HOWARD COUNTY HISTORIC PRESERVATION COMMISSION

June Minutes

Thursday, June 2, 2016; 7:00 p.m.

Figure 6 - Aerial of property

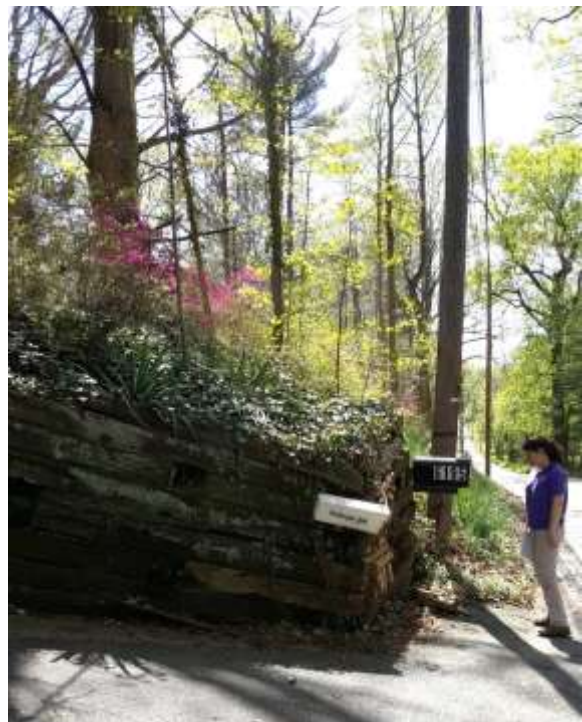
Staff Comments: Chapter 9.D explains, “because homes in Lawyers Hill fit into the natural contours of the surrounding hills, the need for retaining walls has been minimized, and they occur infrequently within the District. Retaining walls in the District are generally low, brick or stone walls that have been built to form decorative structures such as a flower bed or water fountain. High timber retaining walls have been used at one driveway entrance to minimize the need to clear and grade the adjacent slopes. New retaining walls that will be visible from public roads or neighboring properties should be unobtrusive and constructed or faced with brick or stone.” Staff is concerned about removing the timber walls and replacing it with the concrete segmented wall system. The Guidelines recommend, “design new retaining walls to be low and constructed or faced with brick or stone.” Staff does not find the proposed material is appropriate as is it not brick or stone, but a concrete product. The Guidelines recommend against, “retaining walls faced with timber, concrete or concrete block, unless these walls are not visible from a public road or neighboring property.”

The Guidelines also recommend, “where higher retaining walls are required, consider using a series of short, stepped walls with landscape plantings rather than one single high wall” and “soften the appearance of highly visible new walls by planting vines or other landscape materials that will cover the wall.” Staff has inquired with the Applicant if he has considered grading the site to achieve either a lower wall, or no wall, or if he has considered terracing the wall to reduce the overall height of the wall. The Guidelines also recommend, “minimize the need for new retaining walls by designing improvements, including driveways and parking area, to minimize clearing and grading.” Staff finds this recommendation is unclear and does not know the intent of the statement as it seems contradictory. In this instance, slight grading would reduce the need for a high wall.

Staff has requested a plan of the proposed expansion on a plot plan to ensure the expansion will take place on the Applicant’s property, as the driveway is close to the property line. The three trees to be removed are large trees, most likely 12 inches or greater at diameter breast height. However, their removal for the expansion and setback of the driveway apron would not be an intrusive change as the area is wooded. The Guidelines recommend retaining trees and minimizing the “removal of mature trees and shrubs and provide for their replacement with similar species whenever possible.” As this site is wooded, Staff does not find their in-kind replacement is necessary, but would recommend planting trees or shrubs in their place if possible. The azaleas will most likely need to be removed, but Staff would recommend retaining them if possible or replacing any removed azaleas.

Staff Recommendation: Staff recommends a concrete or concrete block wall with a stone or brick veneer be constructed. Staff recommends Denial of the segmental concrete block retaining wall product.

Figure 14 - Amenity Area site plan

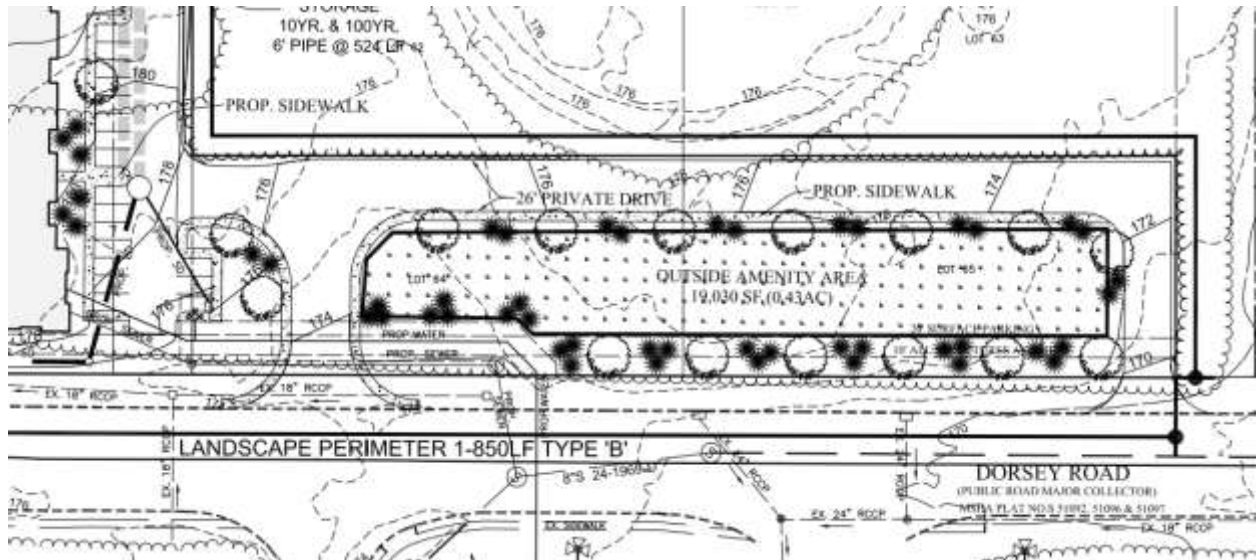
There does not appear to be a relationship between the proposed amenity area and the cemetery. Staff would like to see a provision for access to the cemetery from Dorsey Road provided in the event that the Route 1 access to the cemetery is removed in the future due to development and traffic safety enforcement. The site plan also makes it seem that the loop drive in Rosa Bonheur will be slightly disturbed by the construction of the amenity area as the proposed fence and hedge bisect the existing road.

Additionally, the site is part of a cemetery, which should be recognized through the site design. Staff recommends there be signage added recognizing the cemetery and historic site and parking should be available to those wishing to visit the cemetery.

Figure 19 - Proposed alterations

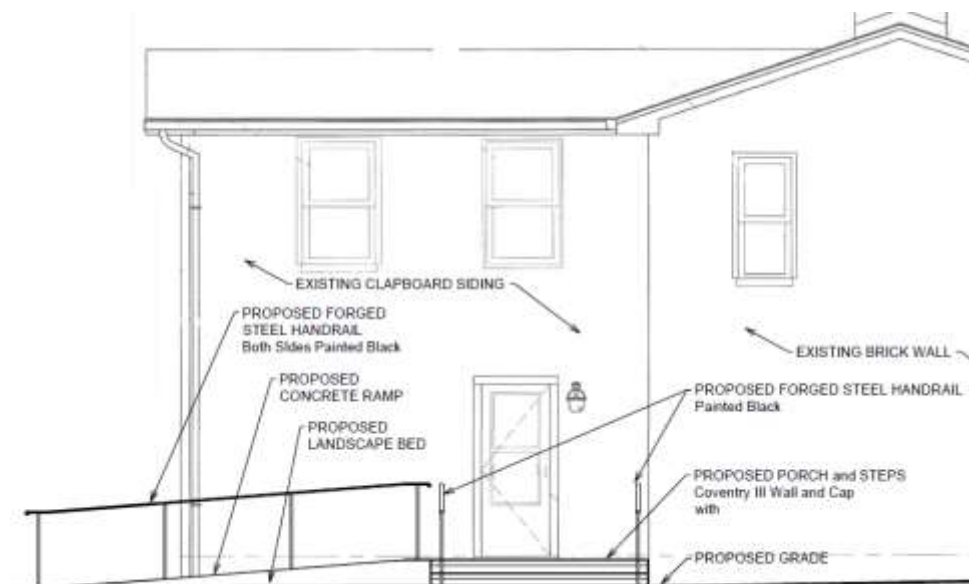
While the tent structure is quite large in comparison to the historic house, it is set off to the side of the house and the view of the house is not disturbed. Vegetative screening has been added against the street. The same materials are used in the tent structure, so all hardscaping on the site is consistent and compatible with the historic building. Staff recommends adding vegetative screening behind the historic house and tent to screen the greenhouses from the viewshed of the historic building and tent.

Staff Recommendation: Staff finds the proposed changes are architecturally compatible with the historic structure as they adhere to the Secretary of the Interior Standards for Rehabilitation. Staff recommends additional landscaping be added to screen the view of the greenhouses.
